Client:- BARRATT HOMES

Site:-
Sinah Lane
Hayling Island

Drawing Title:-
HIGHWAY LAYOUT REVIEW
SHEET 2 OF 2

Drawing No. BSO/E4513/017 G

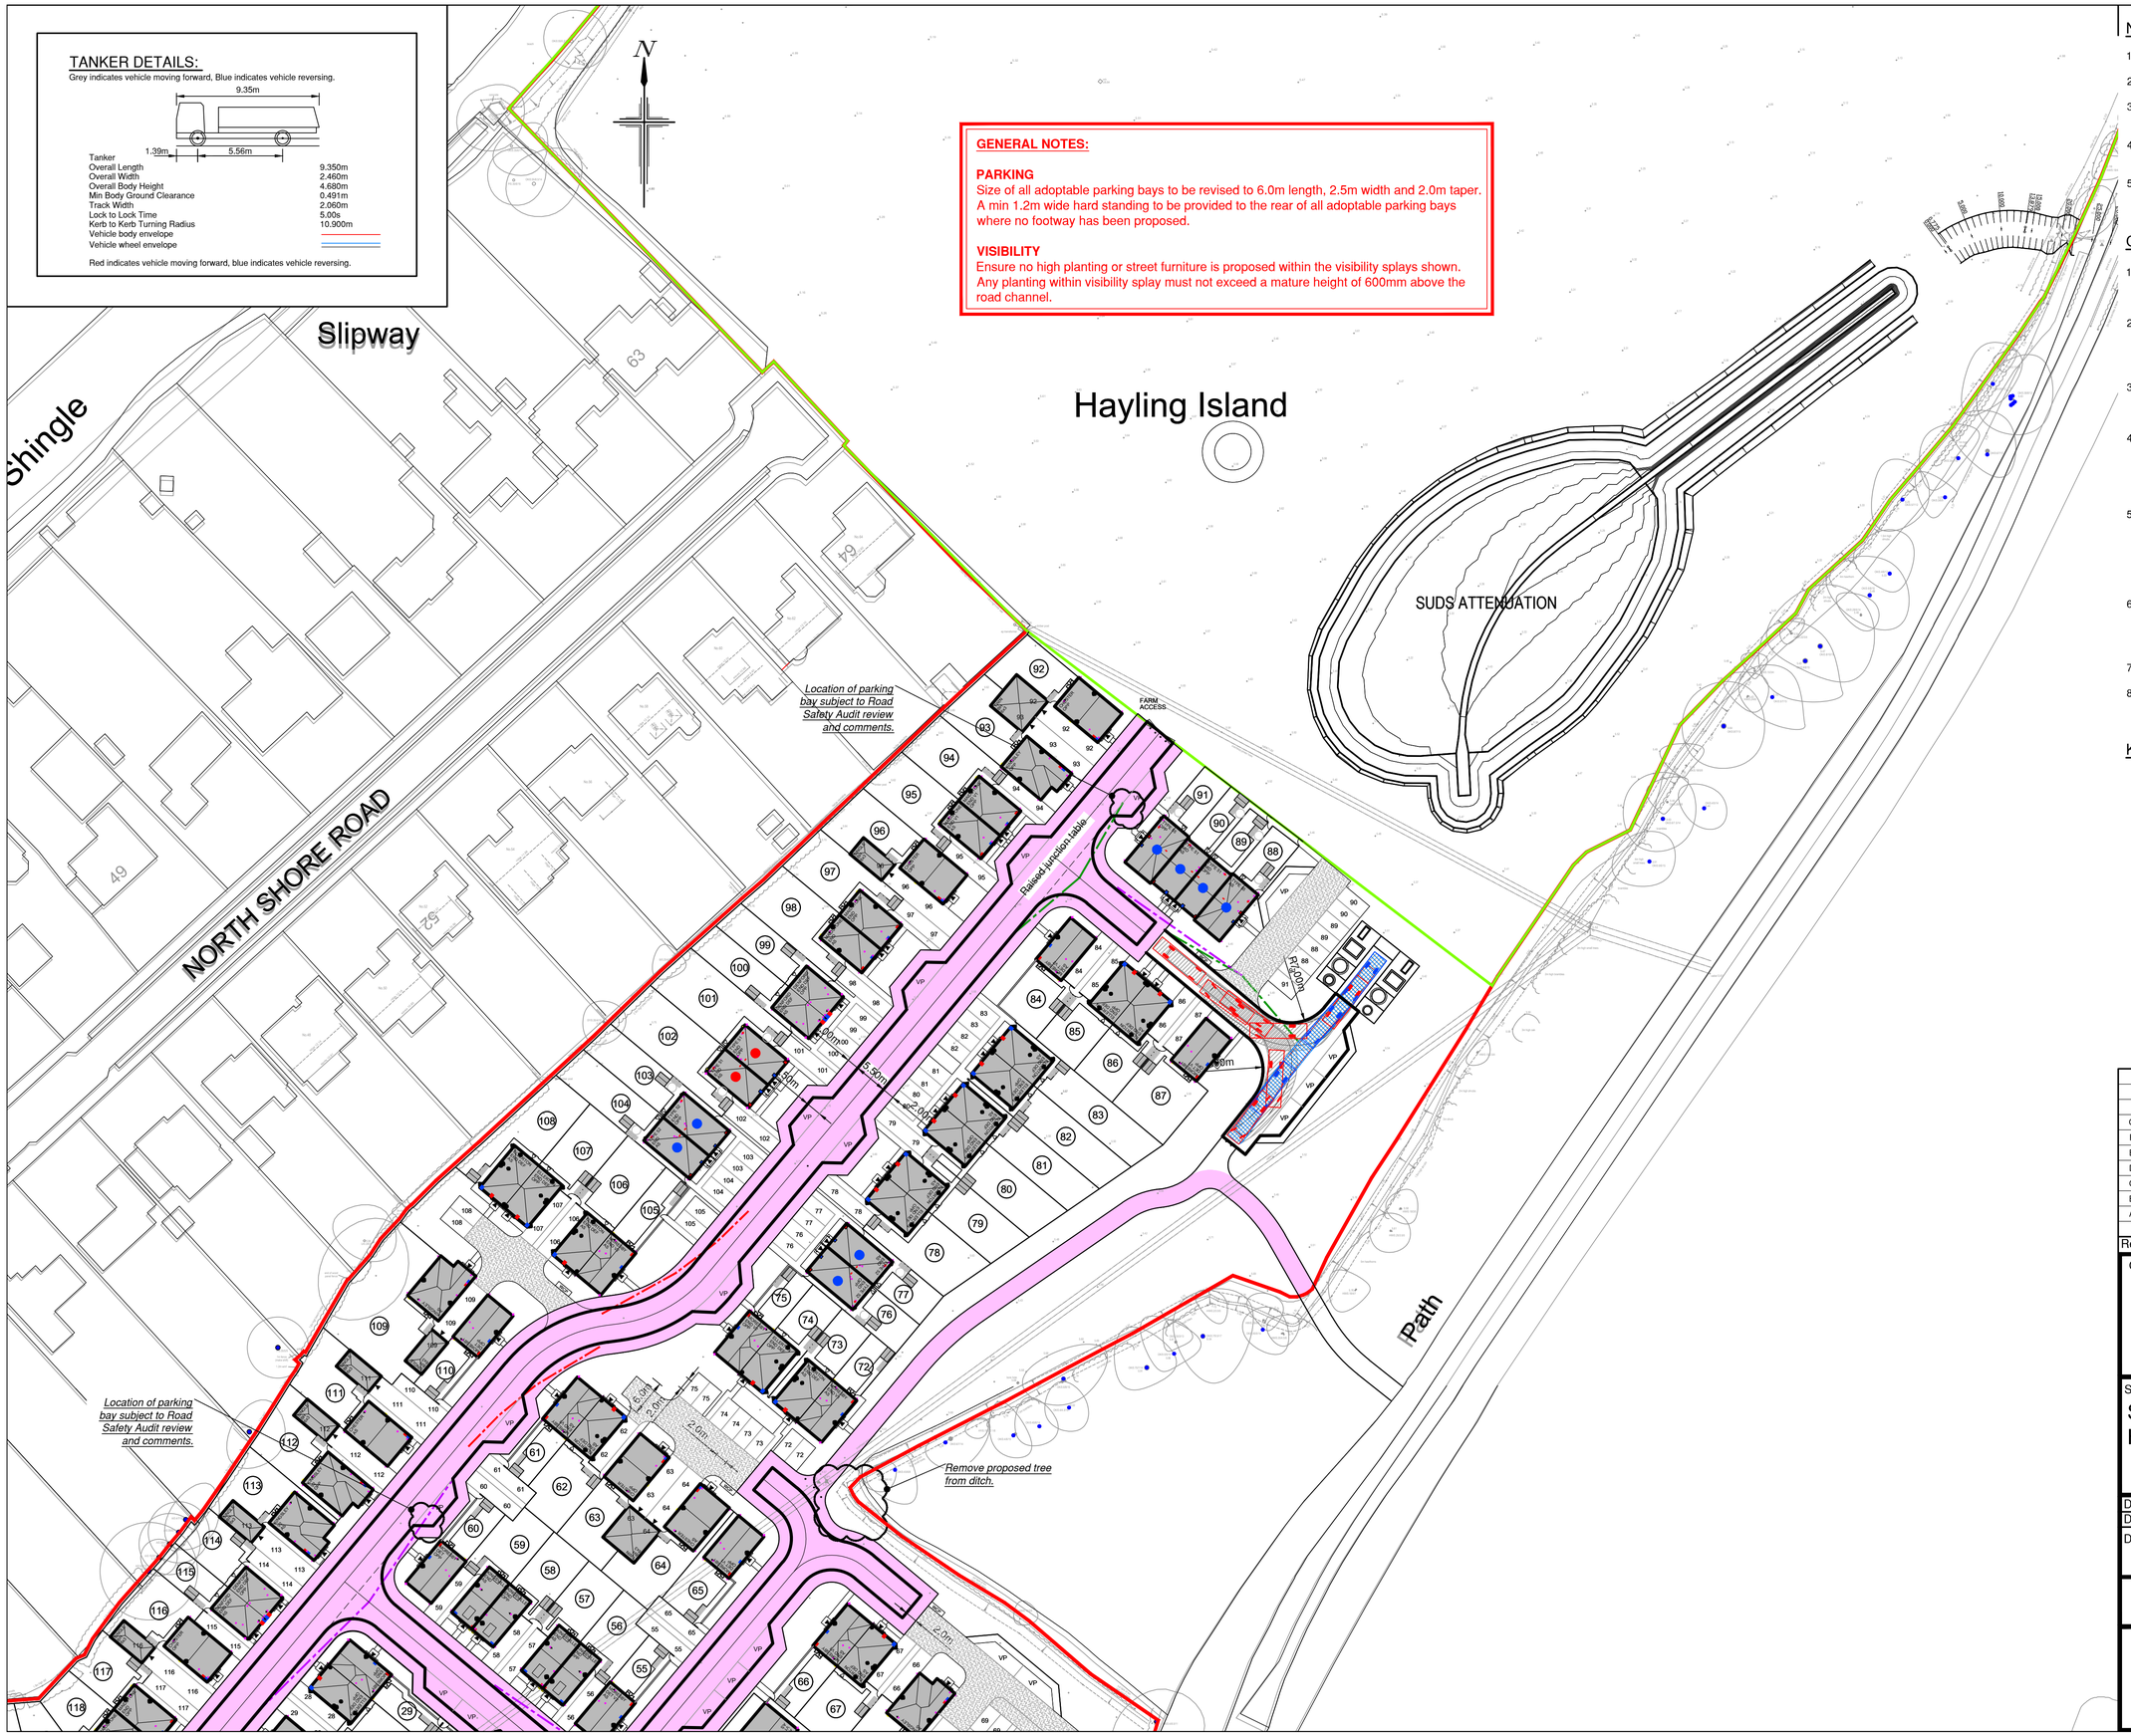
PARKING
Size of all adoptable parking bays to be revised to 6.0m length, 2.5m width and 2.0m taper. A min 1.2m wide hard standing to be provided to the rear of all adoptable parking bays where no footway has been proposed.

VISIBILITY
Ensure no high planting or street furniture is proposed within the visibility splays shown. Any planting within visibility splay must not exceed a mature height of 600mm above the road channel.
